Project: E.L. Miller ES - Facility Improvements Project No: 354-35
 Contractor: Centennial Contractors Architect: CDH Architects
 Originator: Ryan Fernandez Date: April 10, 2024

**THE DEKALB COUNTY BOARD OF EDUCATION
CONSTRUCTION CONTRACT CHANGE ORDER**

Project Name:	E.L. Miller ES – Facility Improvements
Project No.:	354-423
Change Order No.:	03
Date:	April 3, 2024

E.L. Miller ES
Change Order No. #3 - Breakdown

SHEET TITLE	LEVEL 1 - PART 2 - NEW WORK - LIGHTING
SHEET NUMBER	E202

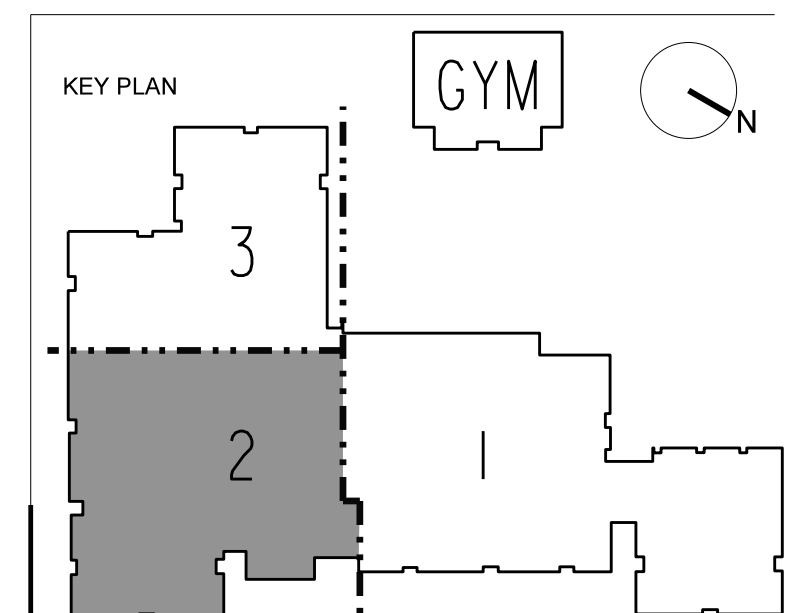
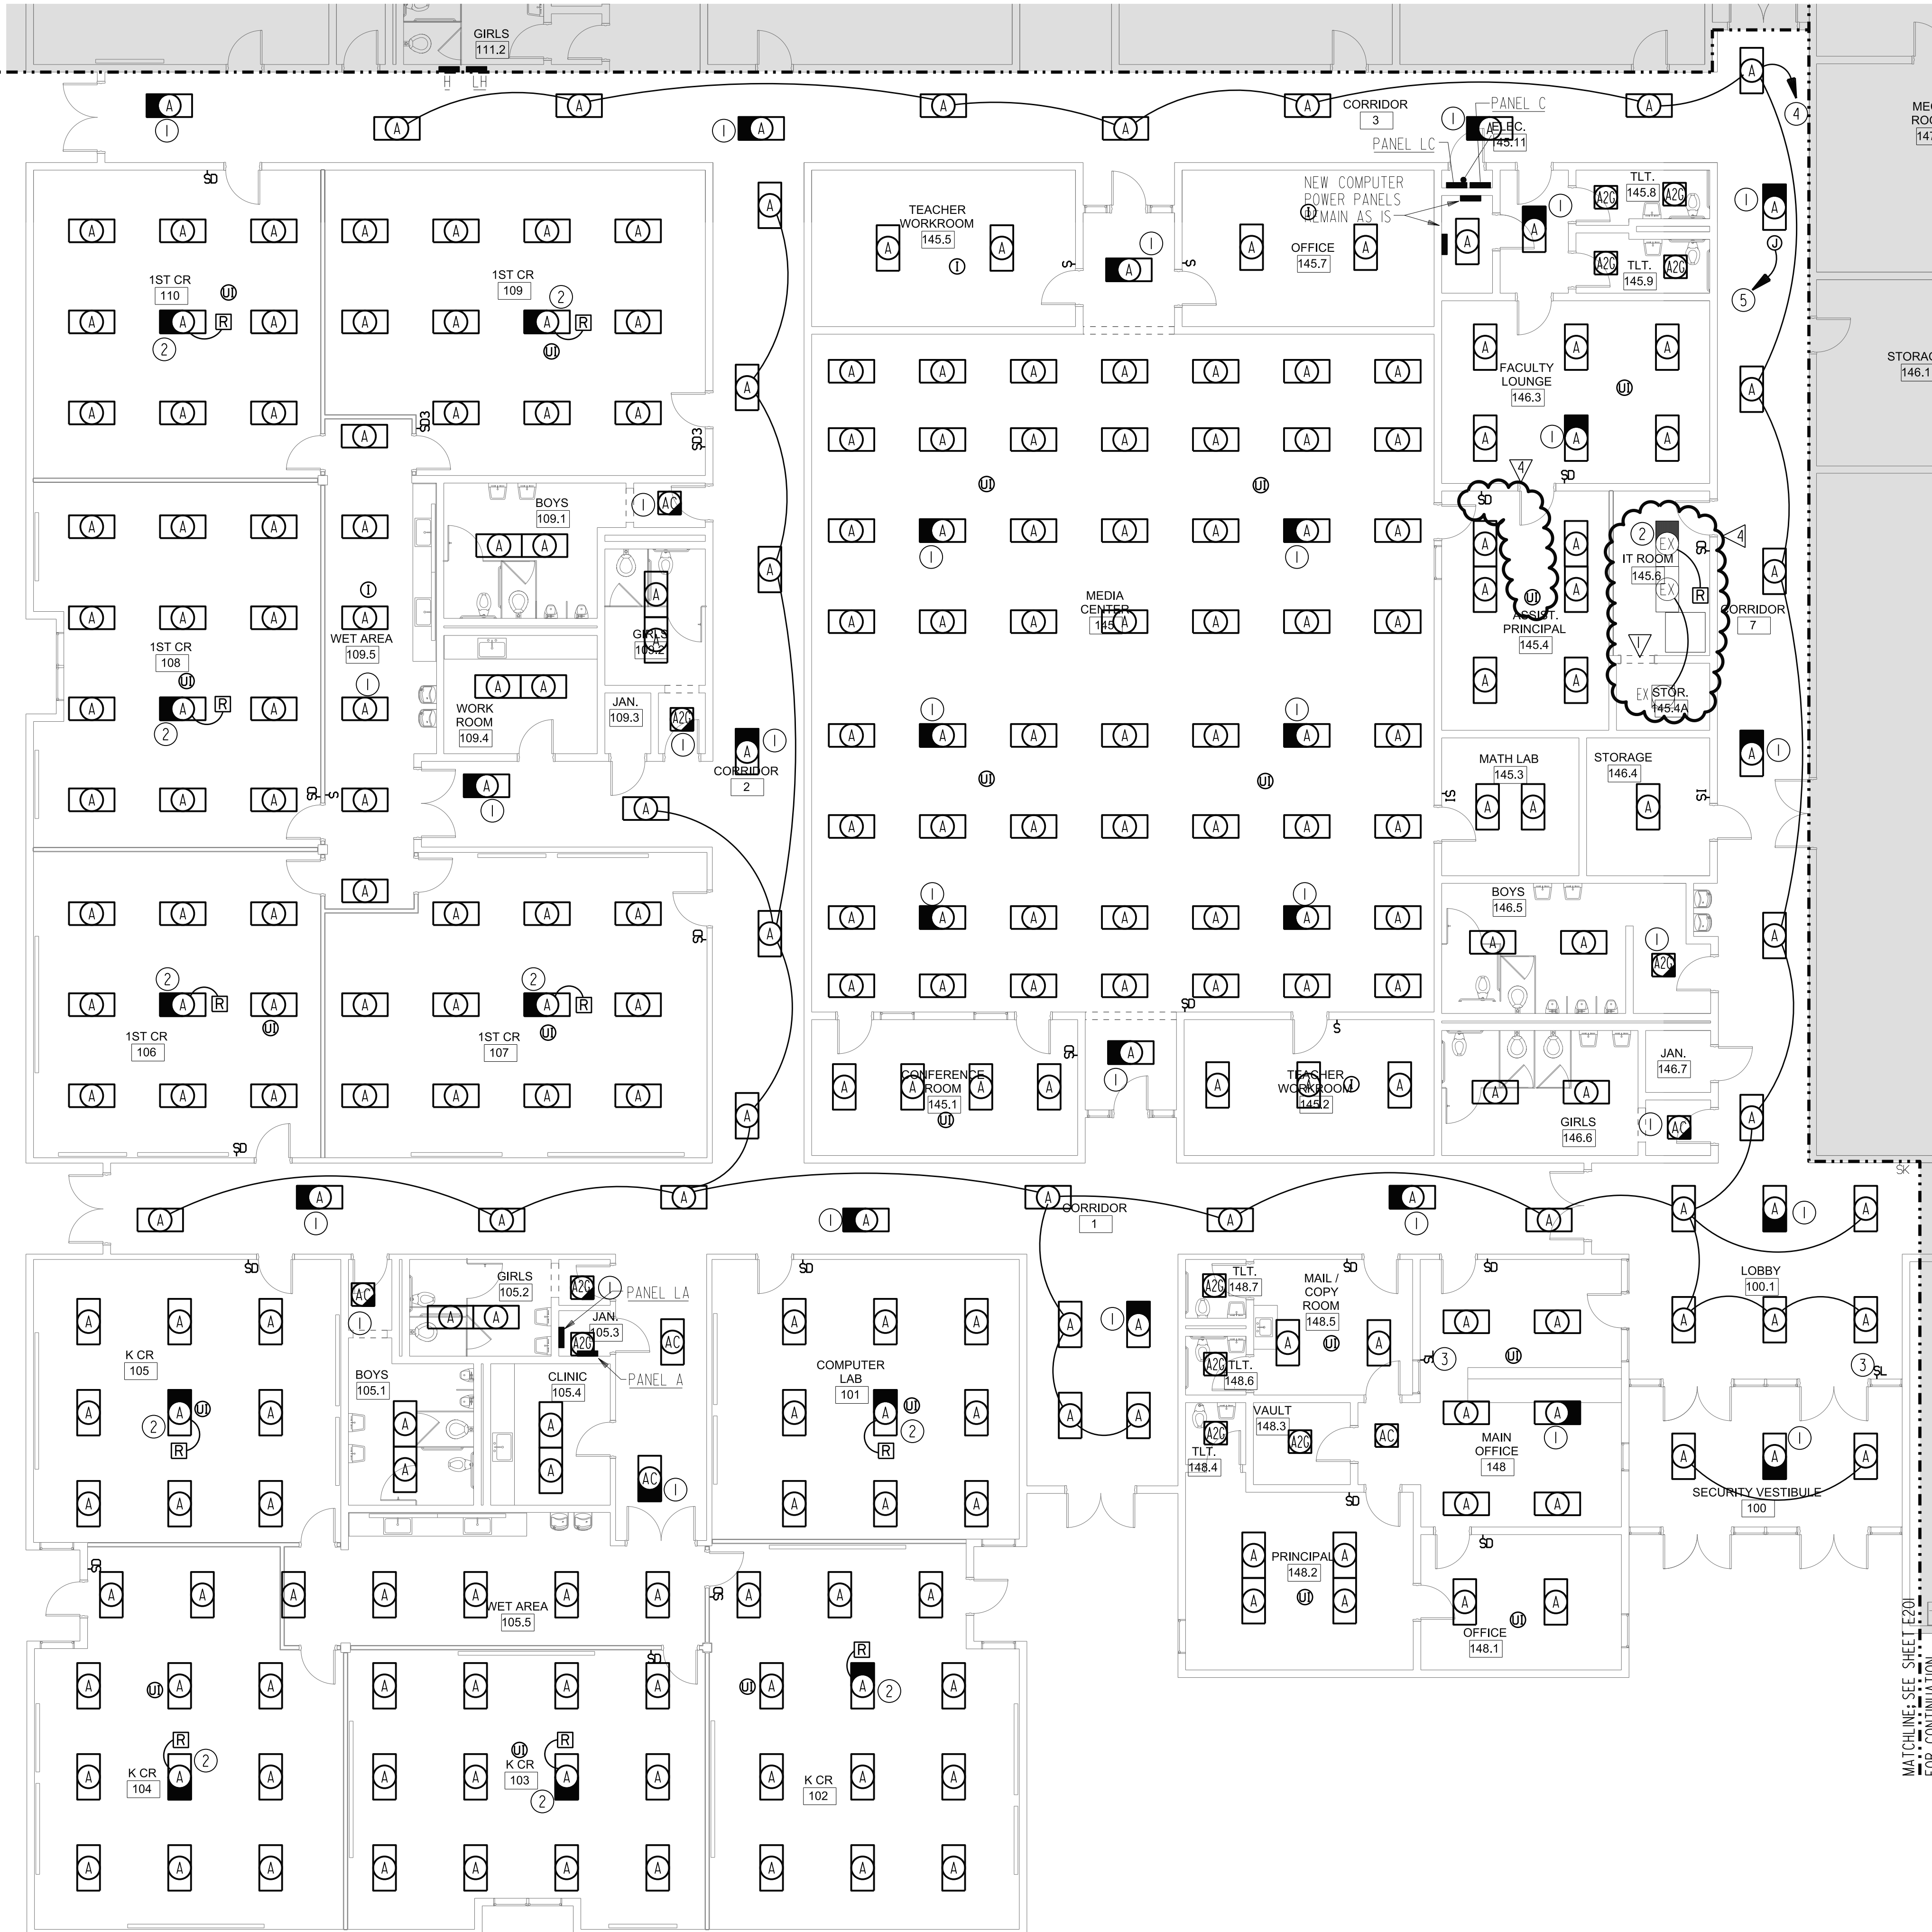
12-04-2023	
4	REV 6 IT ROOM

Per M. Wilson 12/19/23, ECI to provide IT room conversion electrical; including any power, lighting, fire alarm, and intercom.
